Re: Zircaloy Clad  
Conversion  
ISAP Topic 2.17

Haddam Neck Plant  
Additional Information  
Small-Break Loss of Coolant Accident Analysis--  
Zircaloy Clad Fuel

Attachment  
Haddam Neck Plant  
Additional Information

FIGURE 1-5  
HADDAM NECK PLANT ZIRCALOY SBLOCA  
NUREG-0630 RUPTURE TEMPERATURE VS.  
NULAP-5 PEAK CLAD TEMPERATURE  
HOT ROD 5TH UPPER NODE OF 24

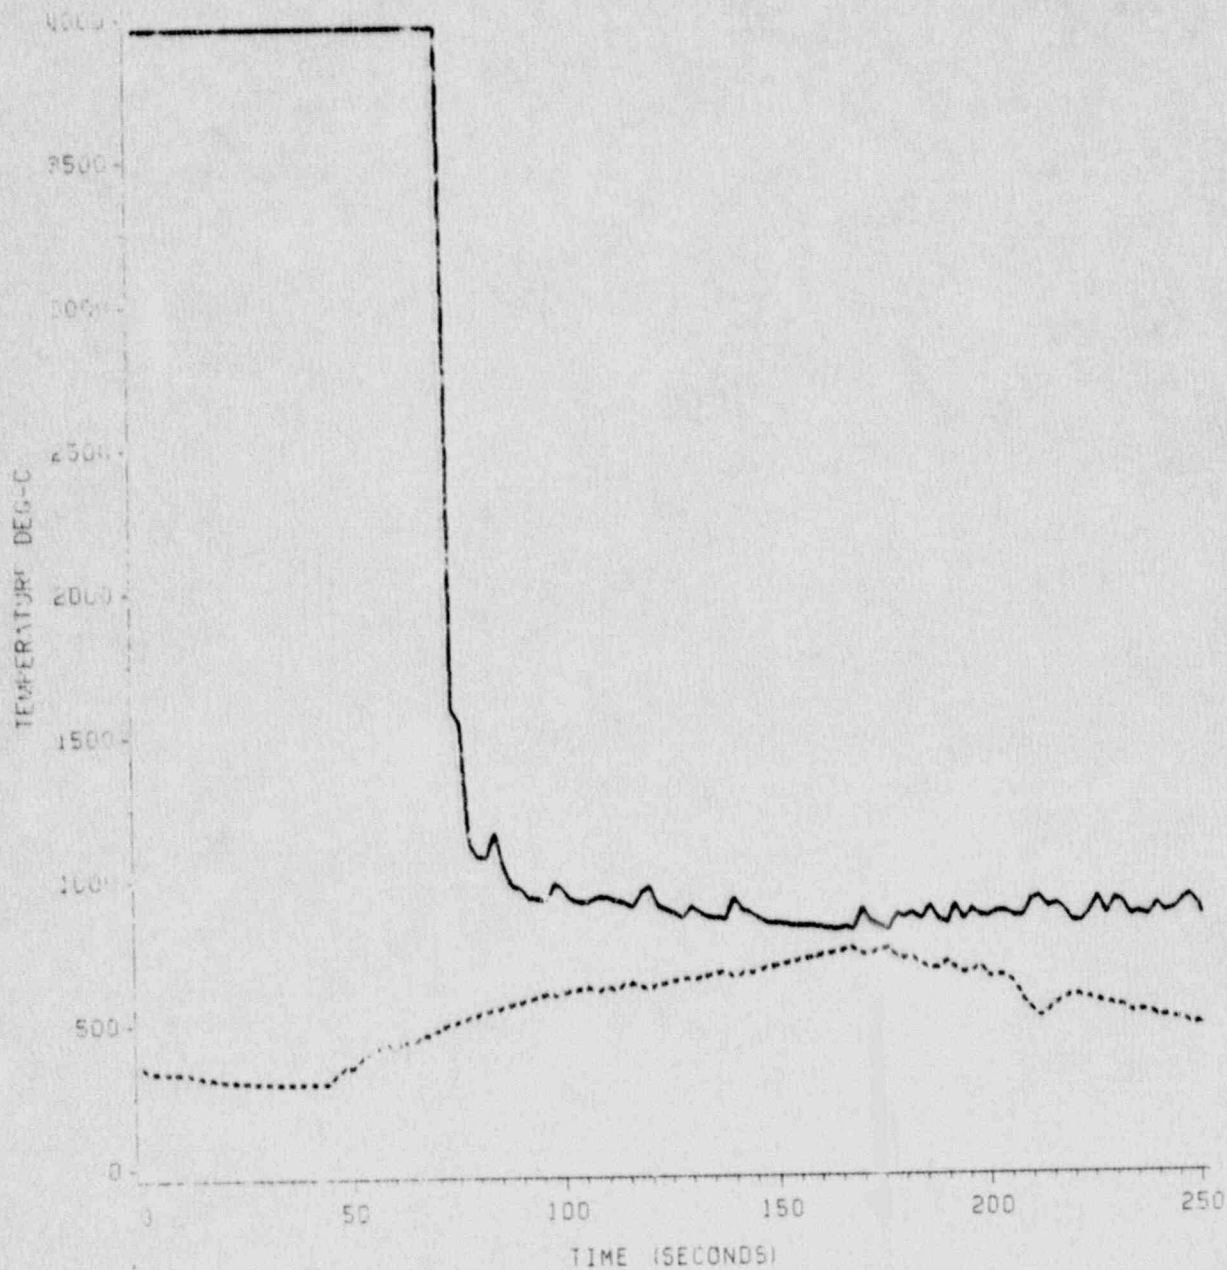
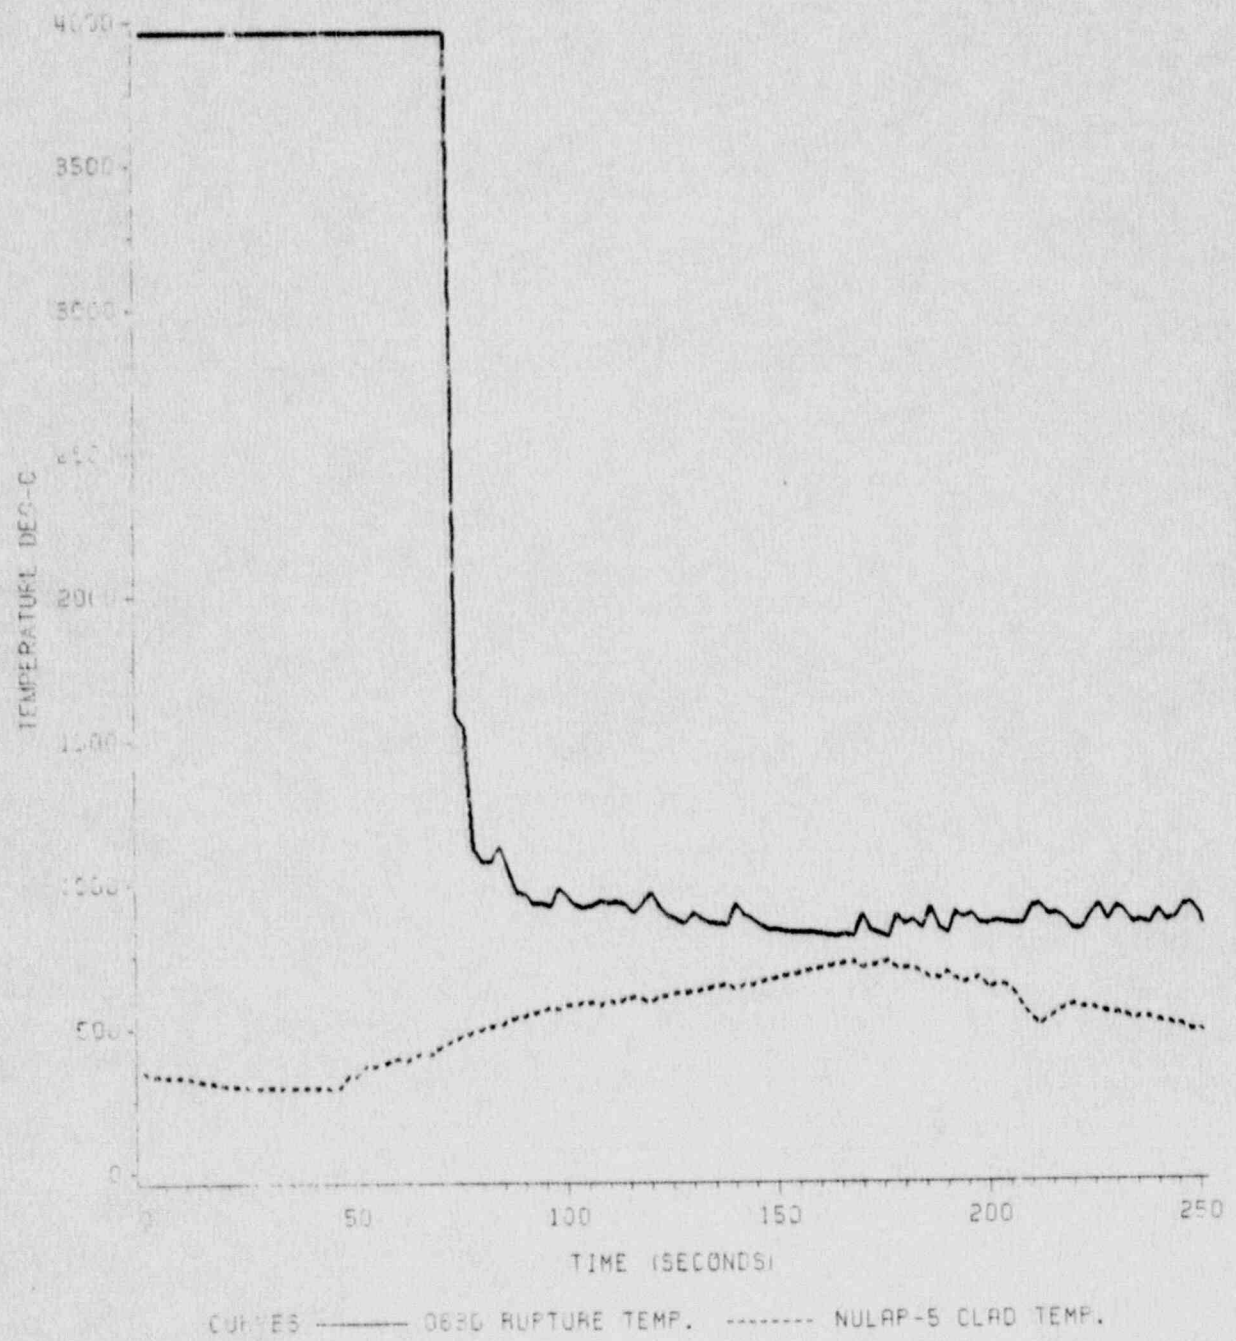
NUREG 0630 provides information regarding the zircaloy-clad material and deformation behavior for use in ECCS licensing analyses. Demonstrate that the clad behavioral model in NULAP5 is consistent with or conservatively bounds the data in NUREG 0630.

The clad behavior model in NULAP5 conservatively bounds NUREG 0630 for the NUSCO 163 break spectrum. The 0.4 ft<sup>2</sup> break was the maximum cladding temperature case (1410 degF) and the only case for which any swelling was calculated to occur by the NULAP5 method. The 0.4 ft<sup>2</sup> case has been repeated, imposing NUREG 0630 methods for calculating rupture. NUREG 0630 Equation 3-2 for TR, rupture temperature, and 3-1 for hoop stress were solved throughout the transient using NULAP5 transient data for clad differential pressure and heating rate. As shown in the attached 7 figures of clad temperature and rupture temperature vs. time for the top 7 of 24 hot rod nodes, NUREG 0630 rupture conditions are never achieved. NUREG 0630 deformation in the form of reduction of flow area follows only from rupture. Thus, using the NUREG 0630 data, no swelling would be predicted. Therefore, any calculation of swelling, as NULAP5 did calculate for the 0.4 ft<sup>2</sup> break, conservatively bounds NUREG 0630 data.
